VERMONT YANKEE CONTROLLED DOCUMENT TRANSMITTAL FORM

DOCUMENT TITLE: IMPLEMENTING PROCEDURES TO THE E-PLAN

CHANGE NUMBER: #188

Re: VY Eplan Implementing Procedure Change # 188, Instruction Sheet

FIGURE 1 - GENERAL EMERGENCY PARs

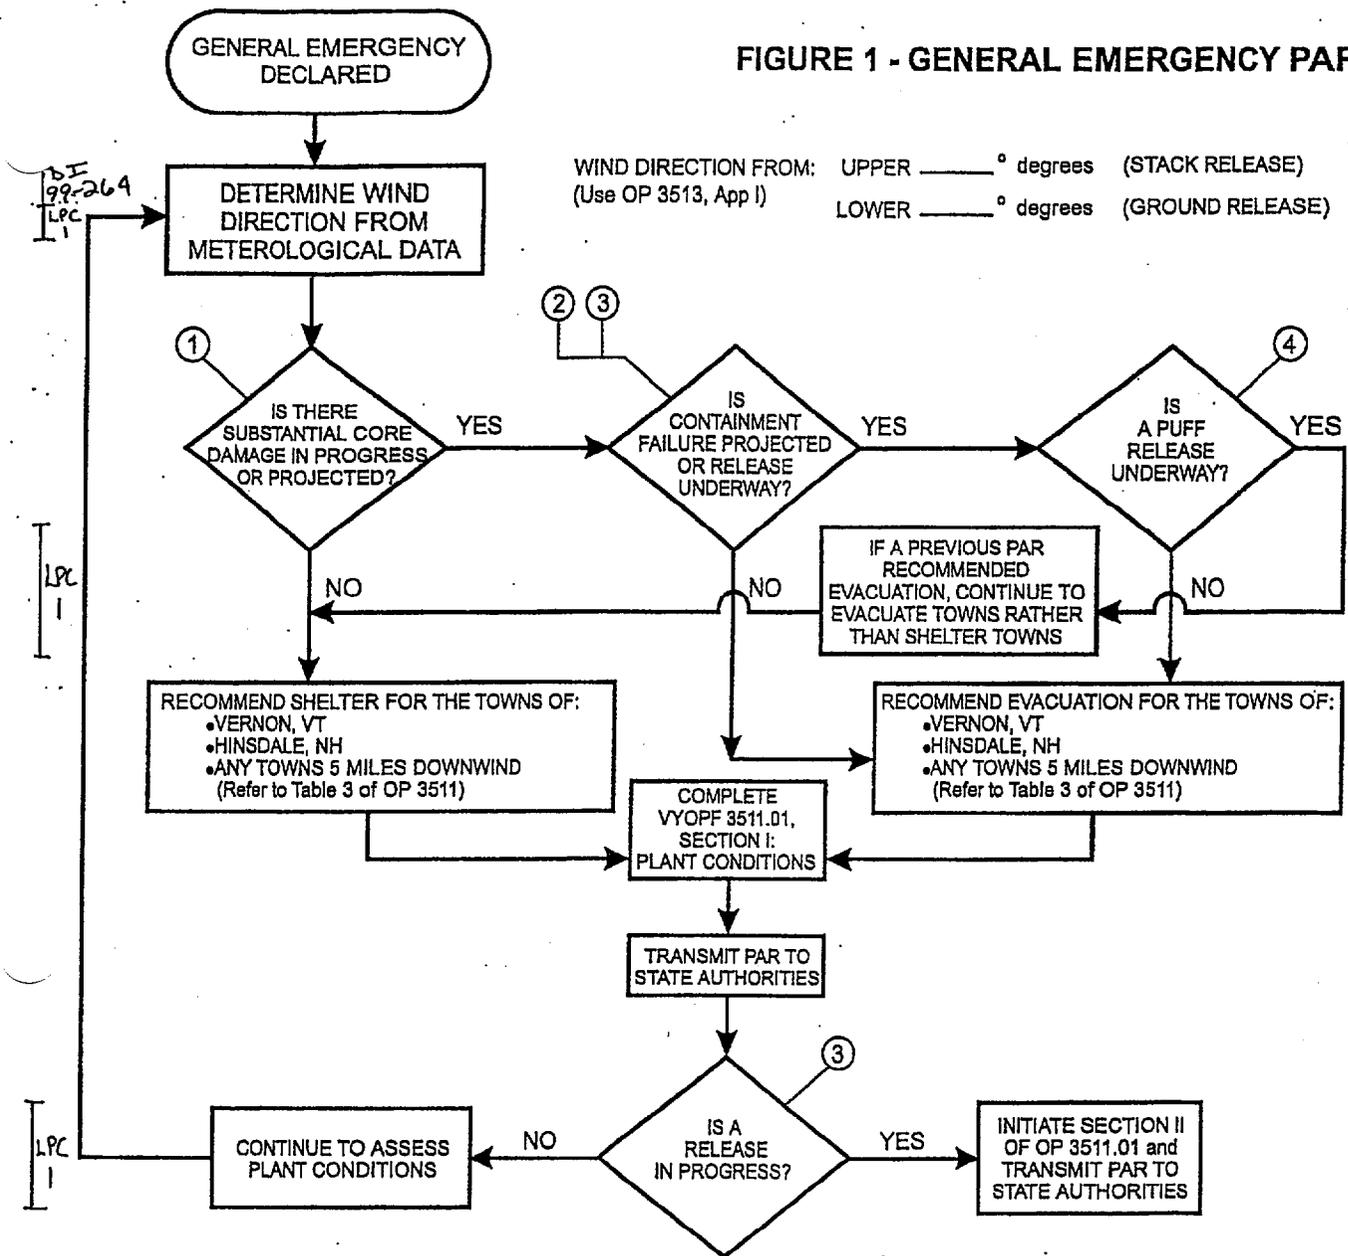
| LPC No. | Effective Date | Affected Pages |
|---------|----------------|--|
| 1 | 10/05/00 | Cover Page, 1, 2, 4 & 5 of 8; VYOPF 3511.01 Pg 1 of 1; Table 3 Pg 1 of 1; Figure 1 Pg 1 of 1 |
